United States Patent and Trademark Office

| APPLICATION NO. | FILING DATE | FIRST NAMED INVENTOR | ATTORNEY DOCKET NO. | CONFIRMATION NO. | |
|--|-------------------|----------------------|---------------------|------------------|--|
| 10/757,610 | 01/14/2004 | Koji Noguchi | 09792909-5758 | 4808 | |

| | Application No. | Applicant(s) | | | | |
|--|--|---|--|--|--|--|
| Office Action Summary | Examiner | Art Unit | | | | |

DETAILED ACTION

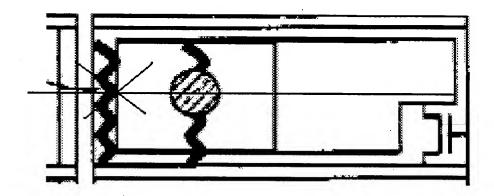
Applicant's arguments filed 7/18/2006 have been fully considered but they are not persuasive. Regarding claim 1, the claim was amended to include the limitation of "the central position being adjacent to a starting position of the rubbing direction and to a boundary not parallel to the rubbing direction."

The X denotes the region the protrusion should be adjacent to. In view of these figures than if application's protrusion is considered adjacent "the central position being adjacent to a starting position of the rubbing direction and to a boundary not parallel to the rubbing direction" than the reference could also be interpreted as meeting the limitation considering a broad interpretation of adjacent. As the limitation does not clearly define the claim as stating that one figure meets the limitation while the other clearly does not.
